s.s. "N.T.NIELSEN ALONSO"

W107-0149

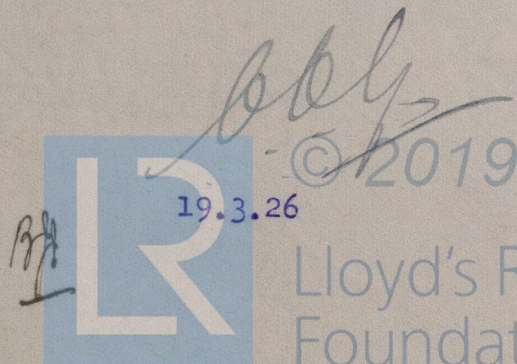
It is submitted it be pointed out to the Surveyors that the plan forwarded is incomplete and indistinct, and is not such as should have been submitted to this Office for consideration,

To enable the equipment number to be computed, the plan should be completed to show clearly the lengths and character of the various erections, with figured dimensions.

The Framnes Mek. Verks. should first make their own calculation of the new equipment number so far as the deck erections are concerned and indicate this on the plan.
